Oriental Motor Asia Pacific Pte. Ltd.

## [Important Notice] Notice and Request Concerning the Safety of Our Motor Driver

1. Product of concern: Driver for brushless motor **BMU Series 30W/60W/120W**  
(For the identification method of the applicable product, please refer to 4. “How to identify applicable product” on the next page)
2. Overview: The shaft that supports the dial (behind the dial) was found to be an electrified part because it is electrically connected to the internal circuit. Therefore, direct contact with the shaft may result in an electric shock if the front dial were to be removed and the driver has power. The driver is safe to use as intended with the dial attached. Please note that the products that we currently ship out are designed with the dial that will not come off.

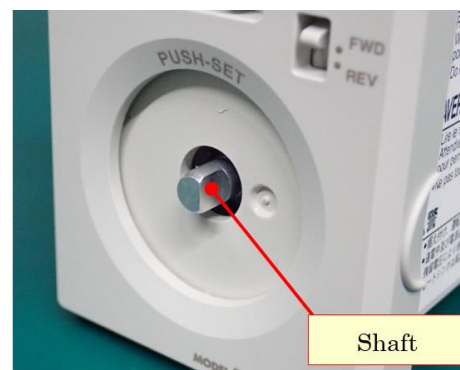
We recently found out, there was a potential for an electric shock when using some of our motor drivers. Therefore, we would like to provide you with the following information and safety precautions for use. If use as intended, there is no safety issues. We sincerely apologize for any inconvenience this may cause and greatly appreciate your prompt attention to this matter.

Safe to use, please **DO NOT** remove the dial and keep it in place while using.

If the dial comes off unintentionally, be sure to turn off the power.

When reattaching the dial, please wait for at least 1 minute after the power is turned off.
